Tallawang Solar Farm – Environmental Impact Statement

Thank you for your e-mail dated 27 October 2022 to the Biodiversity, Conservation and Science Directorate (BCS) of the Department of Planning and Environment (DPE) inviting comments on the Environmental Impact Statement (EIS) for the Tallawang Solar Farm.

Attachment A – BCS's Recommendations

Attachment B – BCS's Detailed Comments

Figure 1 Survey Effort Extract from BDAR

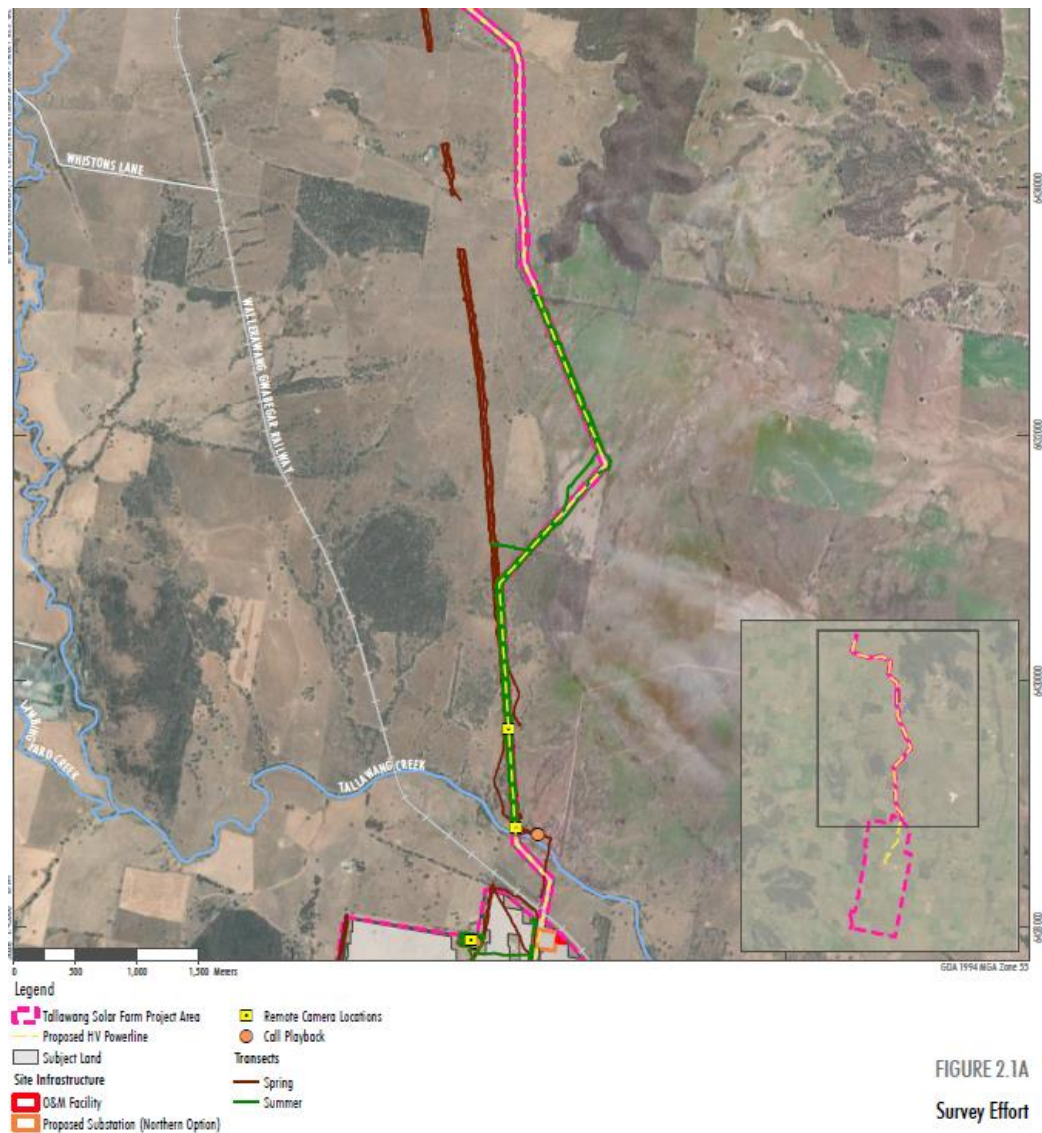
Figure 2.1A - B of the BDAR shows the survey effort that was undertaken during Spring (October), Summer (February) and Winter (June and August).

BCS notes that Spring surveys were not undertaken within the southern portion of the transmission line alignment and instead occurred in an area outside of the subject site, in an alternative transmission line alignment (See Figure 1 below). The unsurveyed area contains both derived native grassland and woodland representing PCT 281, totalling approximately 13 hectares cumulatively.

The following candidate species are associated with PCT 281 which have a survey window limited to Spring:

- Ausfeld's Wattle
- Gang-gang Cockatoo
- Pine Donkey Orchid
- Booroolong Frog
- Superb Parrot
- *Prasophyllum* sp. *Wybong*
- Silky Swainson-pea

The list above would be inclusive of species which can occur in derived native grassland and/or woodland. From review of the BAM-C, these species have been excluded on the basis of targeted survey across the entire subject site.

Justification should be provided on the exclusion of the species above from the unsurveyed habitat within the southern portion of the transmission line alignment in accordance with Section 5 of the BAM. If the unsurveyed habitat represents potential habitat for any of the species above a targeted survey to determine the presence or absence of the species', an expert report or assumption of presence will be required.

- 5.1 Provide justification on the exclusion of the candidate species listed in this response from the unsurveyed habitat within the southern portion of the transmission line alignment.
- 5.2 If appropriate justification cannot be provided, undertake a targeted survey to determine the presence or absence of the species, prepare an expert report or assume presence.

Figure 2 Indirect Impact extract from the BDAR

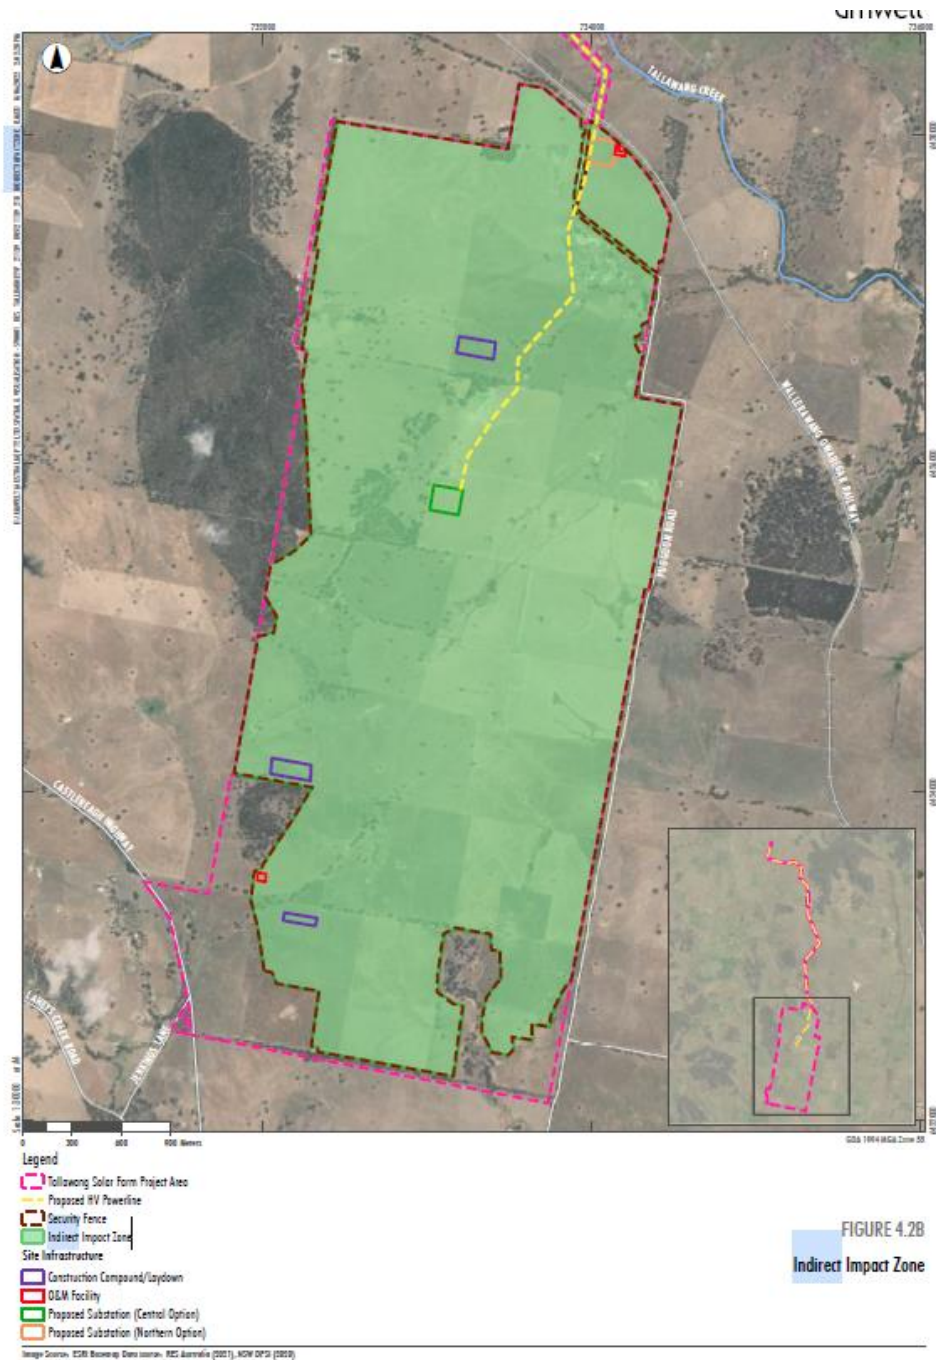
Section 5.1.2 of the BDAR states that *“the project is not expected to result in any substantial indirect impacts on the biodiversity values of the adjacent land. One Indirect Impact Zone has been identified within the Subject Land. The indirect impact is related to the construction of a security fence around the solar farm and BESS development area and has been discussed in Section 5.2. The indirect impact zone was assessed using a 5 m buffer off the security fence layout, refer to Figure 4.2.”*

It is unclear from the BDAR if offsetting of residual indirect impacts is being proposed and, if so, how the buffer of the security fence has been accounted for in the BAM-C. If residual indirect impacts are expected to occur, offsetting of this residual impact should be proposed in accordance with Section 8.6 of the BAM.

It is also unclear how the indirect impacts associated with the construction of the security fence relate the indirect impact zone displayed in Figure 4.2B of the BDAR. This Figure shows an indirect impact zone across the entire of the subject site (See Figure 2).

- 8.1 Provide further explanation on the indirect impacts associated with the security fence and if any residual indirect impacts are expected to occur
- 8.2 If residual indirect impacts are expected to occur, this impact should be offset
- 8.3 Provide clarity on the indirect impact zone displayed in Figure 4.2B of the BDAR
